APPEAL SUMMARY

Appeal ID: 27743	Project Address: 1725 SW Salmon St
Hearing Date: 5/11/22	Appellant Name: Shea Gilligan
Case No.: B-008	Appellant Phone: 6462630183
Appeal Type: Building	Plans Examiner/Inspector: Preliminary
Project Type: commercial	Stories: 7 Occupancy: A-2 Construction Type: I-A
Building/Business Name: High Noon	Fire Sprinklers: Yes - throughout
Appeal Involves: Alteration of an existing structure, Reconsideration of appeal	LUR or Permit Application No.:
Plan Submitted Option: pdf [File 1]	Proposed use: Restaurant

APPEAL INFORMATION SHEET

① LEVEL 1 - Code plan
3/16" = 1'-0"

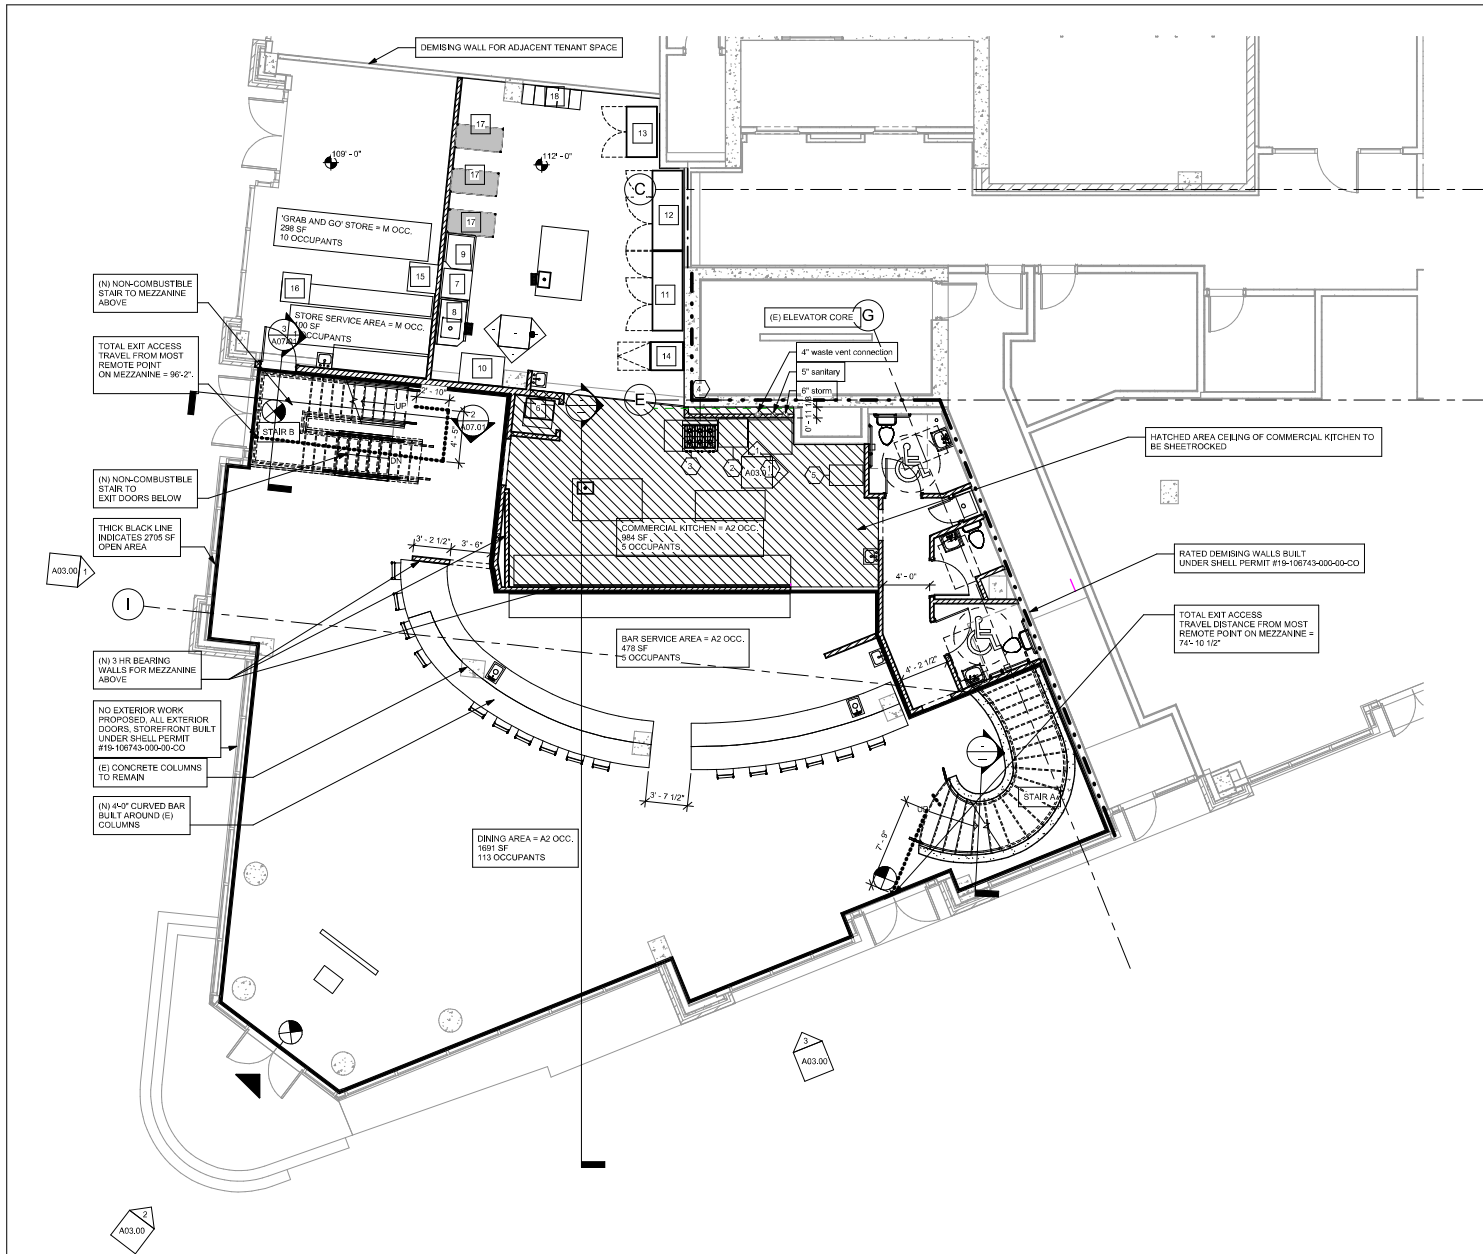
The main restaurant floor has 3 means of egress, each of which are well below the maximum exit travel distance allowed. To exit using Stair A from the most remote part of the mezzanine, the maximum travel distance is approximately 69'-0". To exit using Stair B from the most remote part of the mezzanine is approximately 96'-0". As per Table 1017.2 Exit Access Travel Distance, for an A occupancy with a sprinkler system, the max distance is 250'-0". Our maximum exit travel distance is less than half of the maximum allowable. (See exhibit A for first floor and mezzanine floor plan.)

Stair A has been minorly revised in design development to make the treads code compliant and so the max. travel distance is now 74'- 10 1/2".

Use of combustible Cross Laminated Timber for mezzanine floor in Type 1A construction: Granted provided Type X drywall is used on the ceiling of the kitchen.

① **LEVEL 2 - Code Plan**
3/16" = 1'-0"

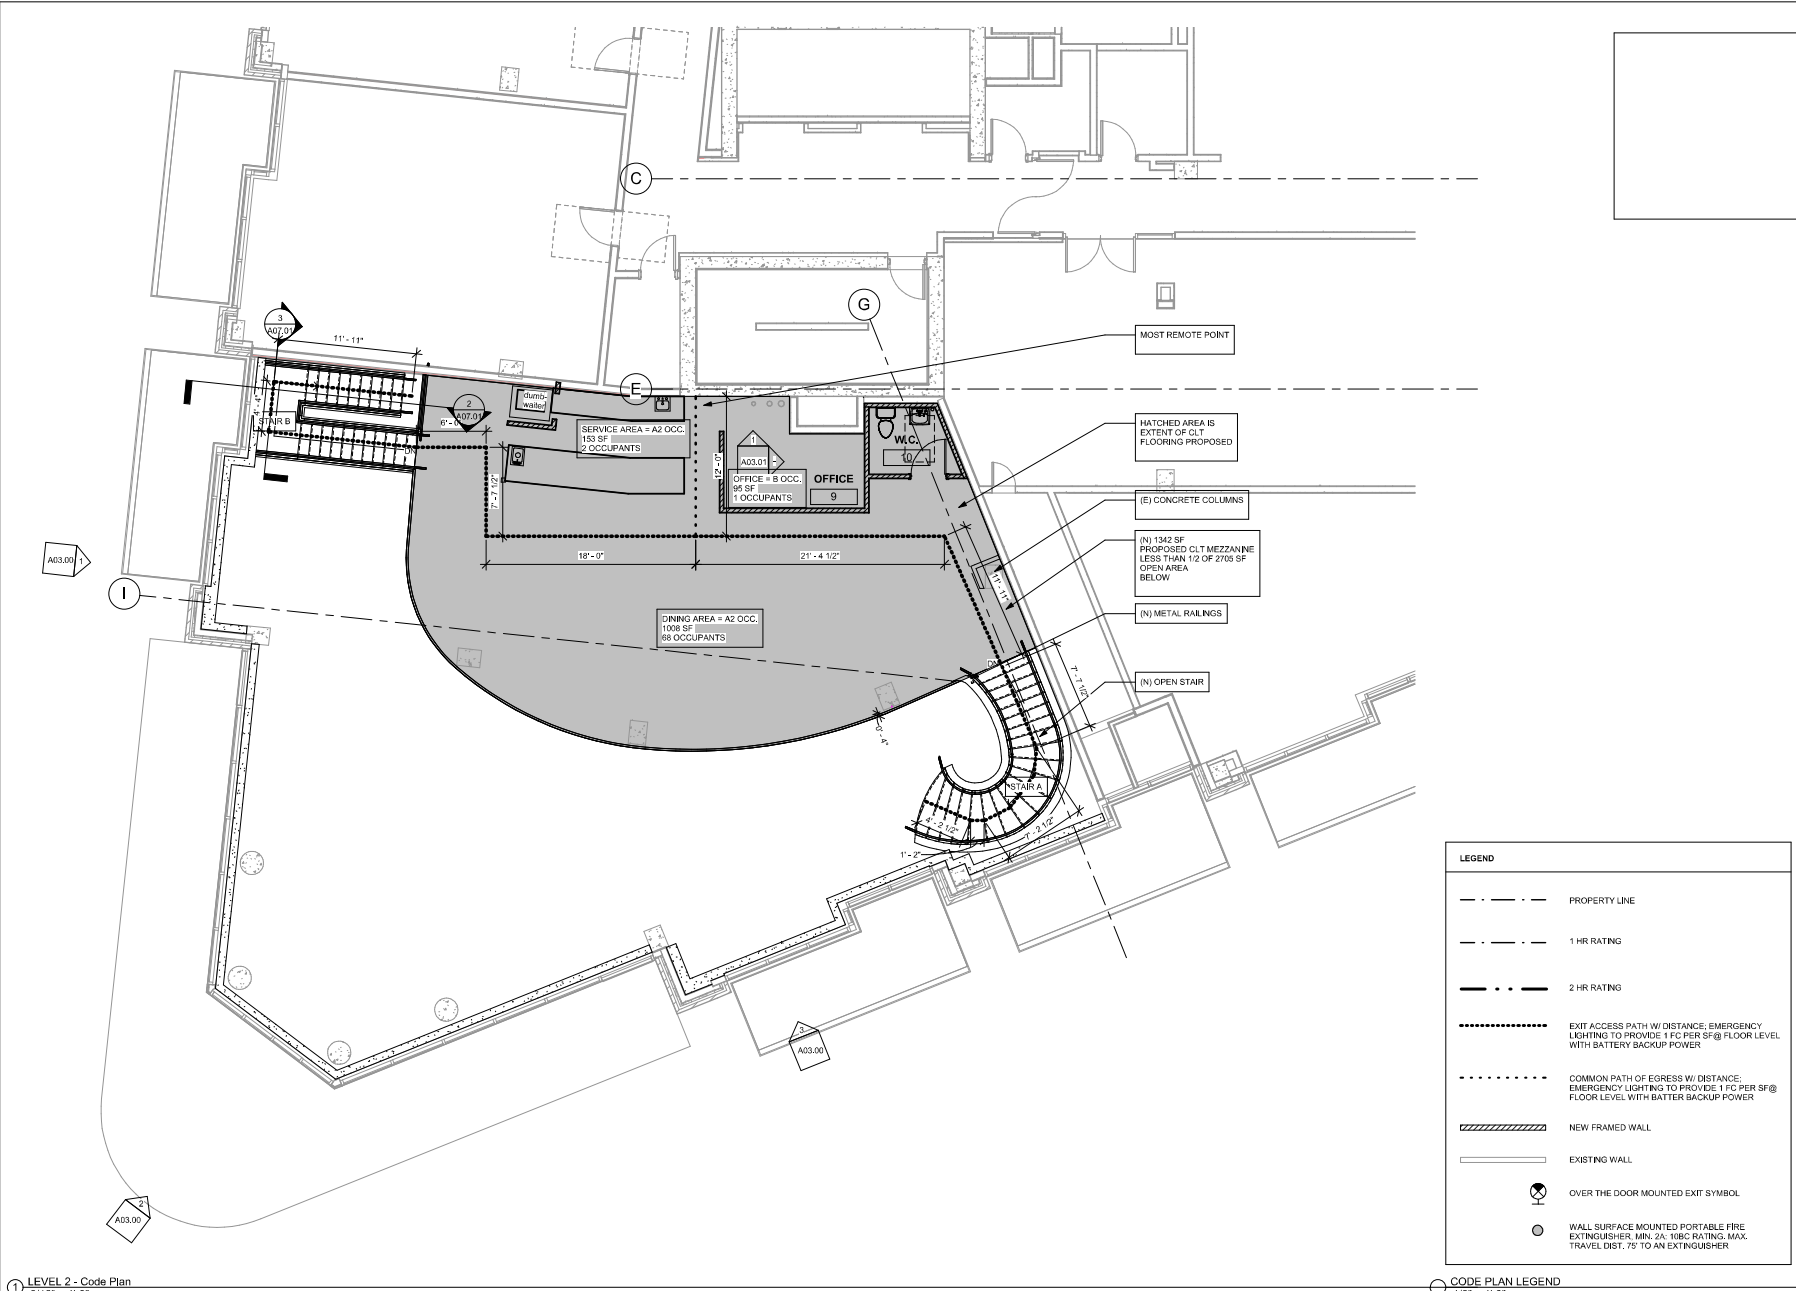
Code Modification or Alternate Requested To allow the mezzanine floor to be CLT, 5-ply (6.875" thick) supported by steel beams with steel and/or concrete columns.

The mezzanine floor will be sprinklered from above and below. Besides one bathroom, there will be no concealed spaces. The 25 sf bathroom is much less than the 10% enclosed allowable. Any concealed spaces in the bathroom will follow rules for Type IV rules for gypsum protection applied directly to the CLT surface.

A minor design modification changes our language for #2. The mezzanine floor will be sprinklered from above and below. Besides one bathroom, there will be one small office. The 95 sf office plus the 39 sf bathroom is less than the 10% enclosed allowable. Any concealed spaces in the bathroom will follow rules for Type IV rules for gypsum protection applied directly to the CLT surface.

Reconsideration text: The addition of the office in the mezzanine reduce the occupant load in the dining area to 69 occupants.
